July 1, 2022

Advice 6635-E

Public Utilities Commission of the State of California

Subject: Modifications to Electric Tariff Rule 21 to Incorporate IEEE 1547.1-2020 Test Procedures into Testing Regime for Phase 2 and 3 Requirements in Compliance with Resolutions E-5000 and E5036

Figure P-1: Voltage and Reactive Default Settings

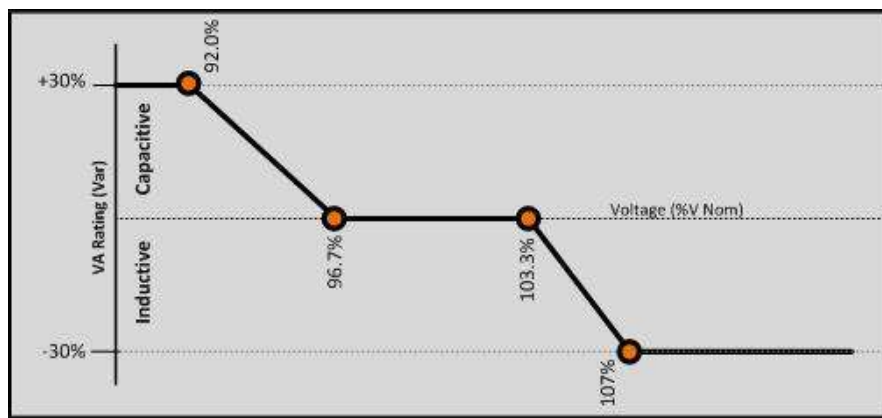
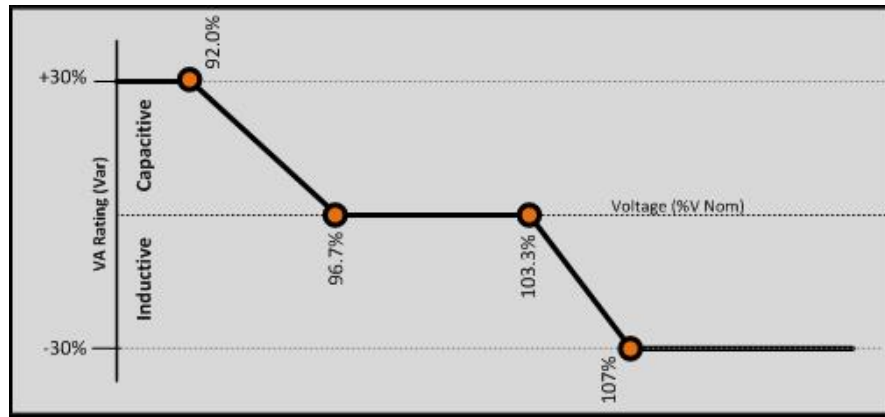
Table P-4 and Figure P-1 depict the default setting, which should be applied for all inverter size. Specific volt/var settings may be required for larger generating facilities (such as 100 kW or greater) or for specific areas with the Distribution System as determined by the Distribution Provider.

Default Open Loop Response Time for volt/var operation setting should be five (5) seconds.

Figure P-3: Volt-Watt Requirements

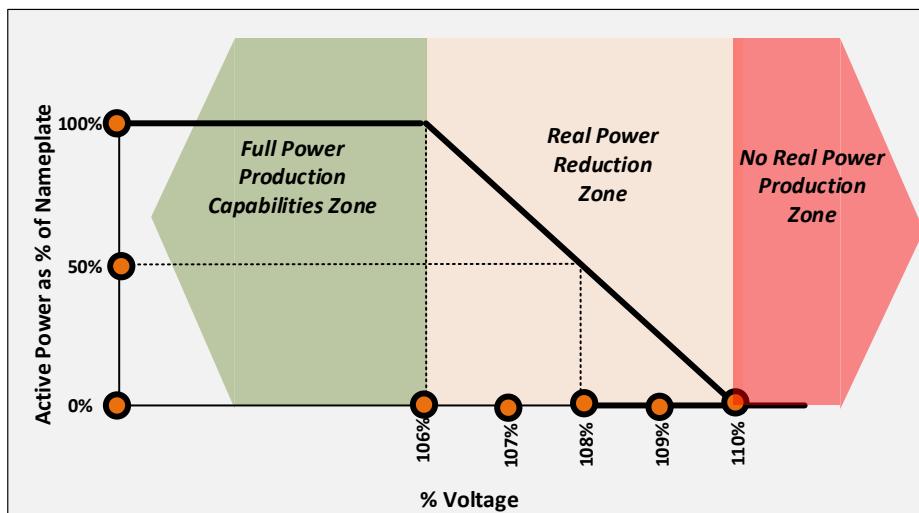
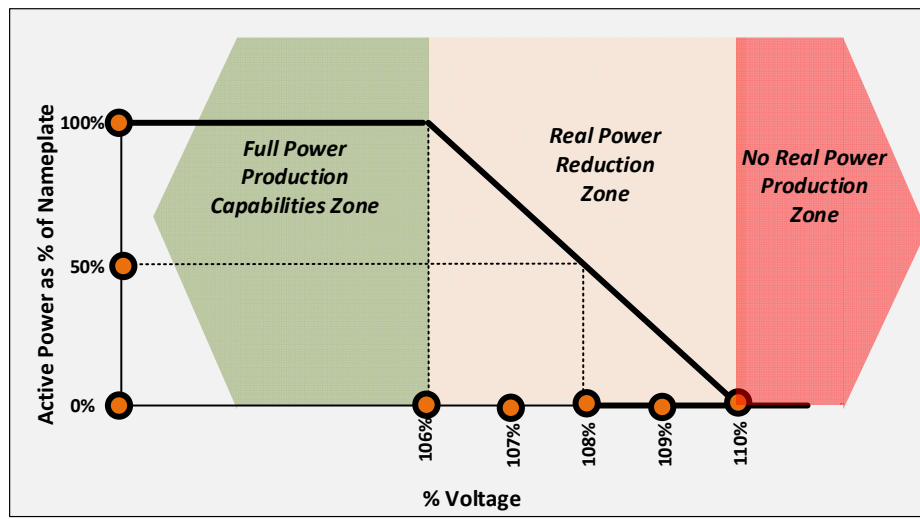
- When the measured voltage is greater than 110% of nominal voltage (Example: 132 volts on a 120 volts nominal), the export of active power to the grid at the PCC or the production of active power by the Smart Inverter shall be reduced to 0 watts.
- Open Loop response time shall be 5 seconds.

Figure P-5: Generating Facility Communications

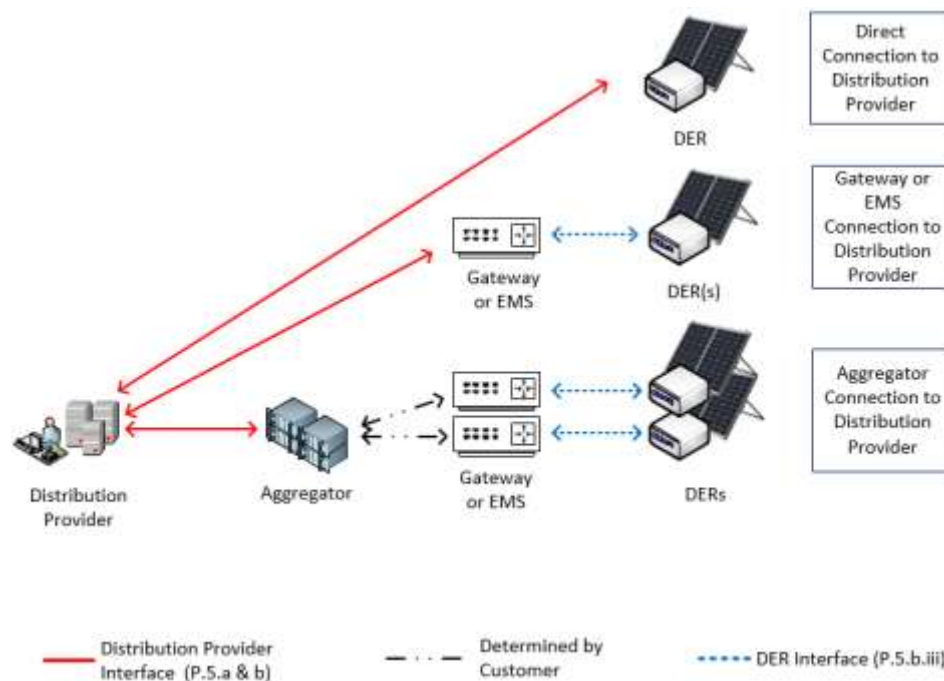
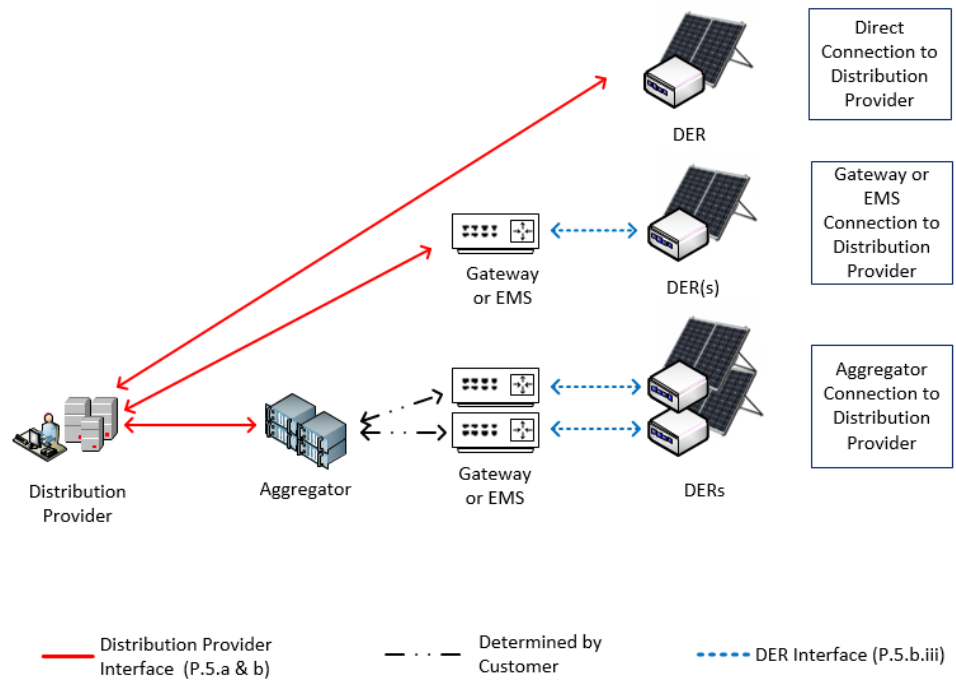
Should communications to the Distribution Provider be required, Generating Facilities utilizing inverter-based technologies must adhere to the following communication requirements for communications between the Distribution Provider and the Generating Facility. The diagram below shows the interface requirements as applicable for section P.5. The Distribution Provider Interface (solid red line) is described in Sections P.5.a and P.5.b. The local DER interface at the Generating Facility (dotted blue line) is described in Section P.5.b.iii. The top row shows a direct connection between the Distribution Provider and the DER. The middle row shows a connection between the Distribution Provider and a gateway (GW) or Energy Management System (EMS). The lower row shows a connection between the Distribution Provider and an aggregator.

G. ENGINEERING REVIEW DETAILS

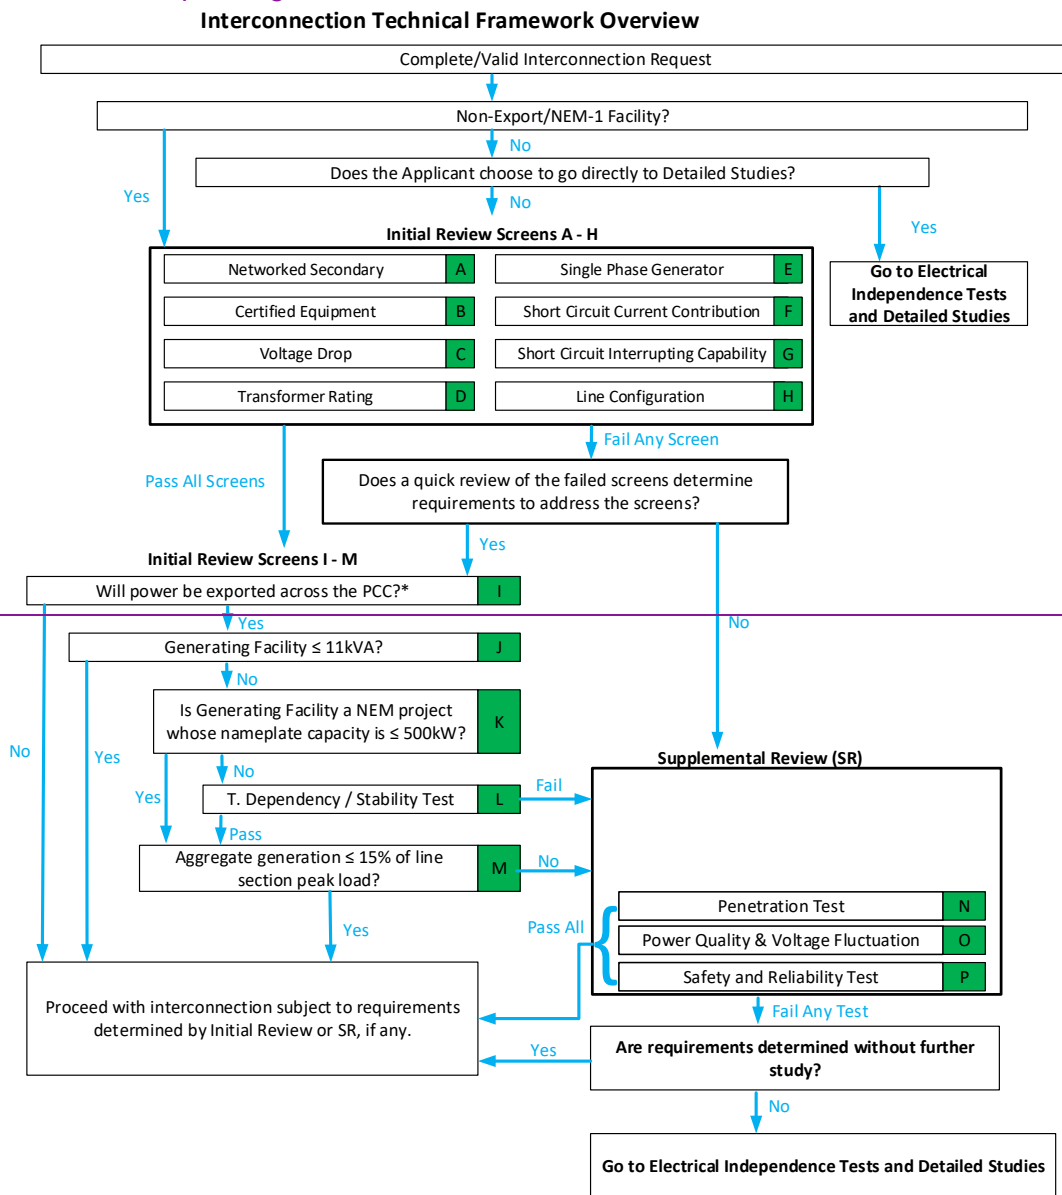
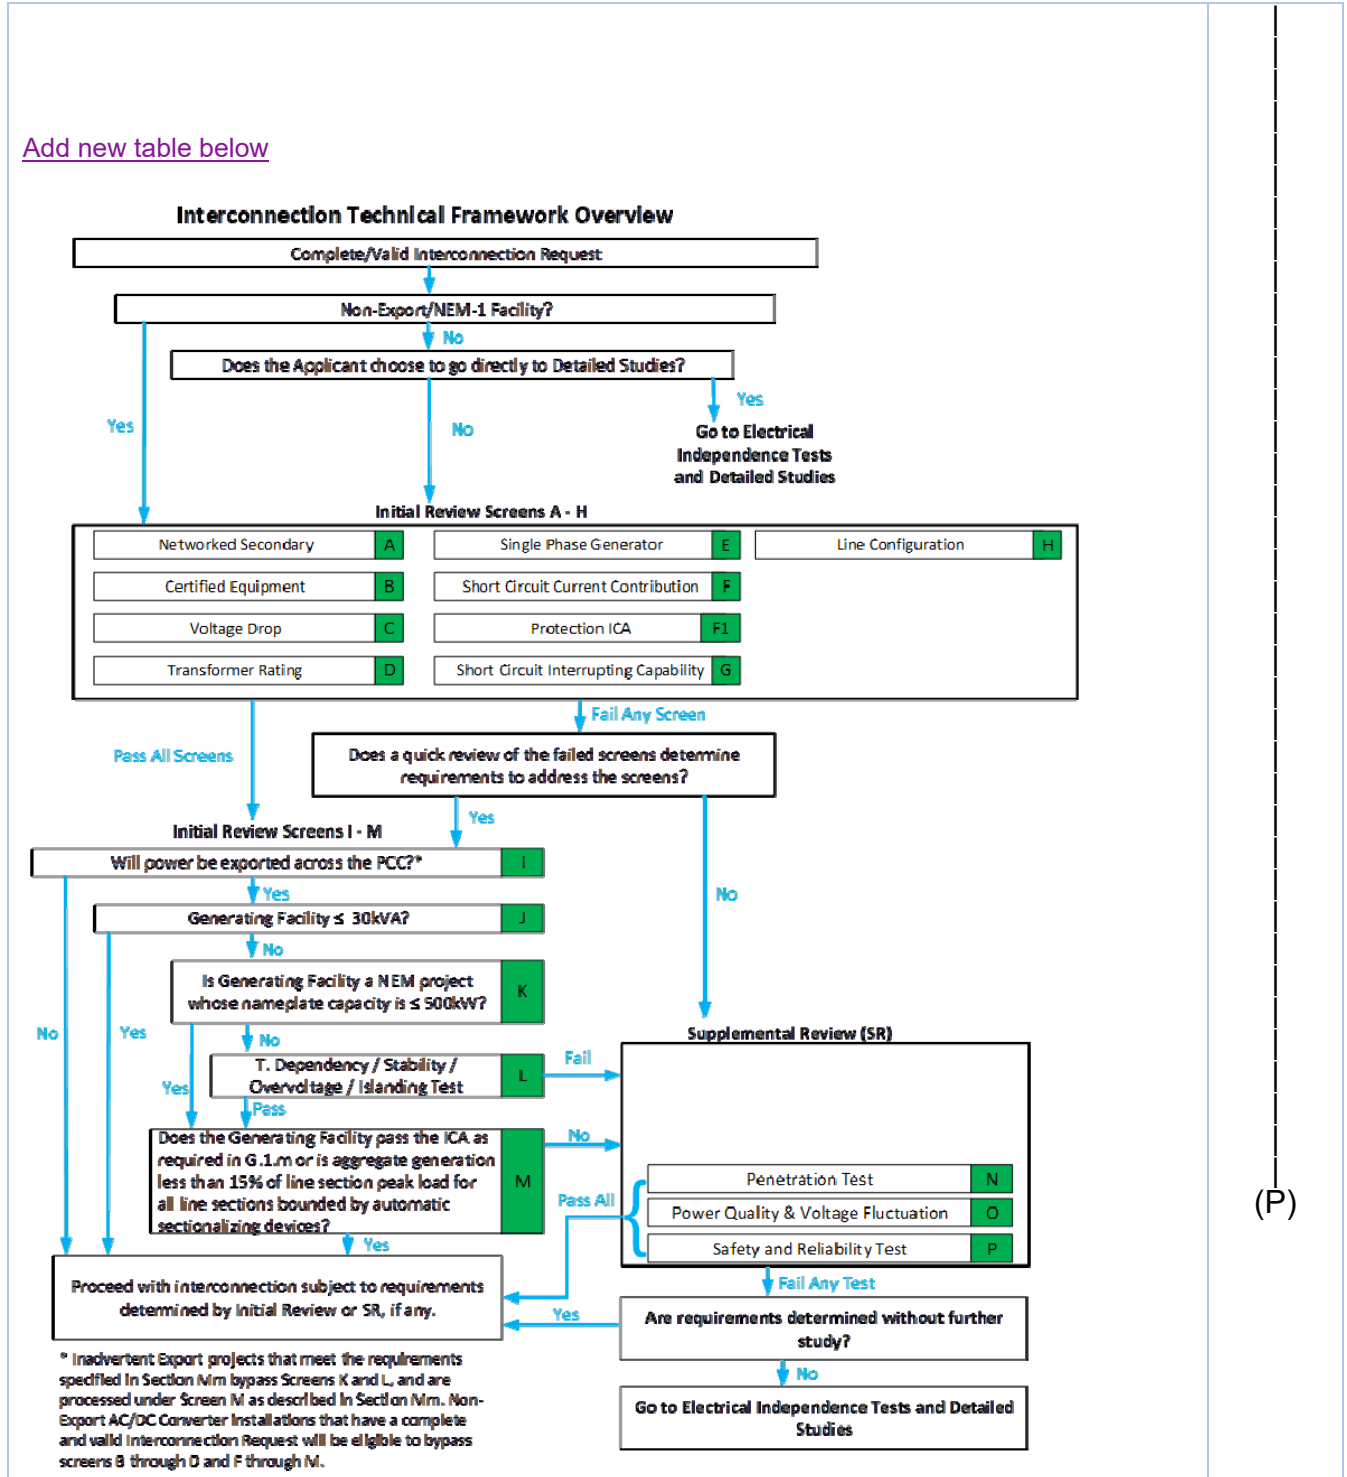
Delete table below:

Delete pending table below:

Add new table below
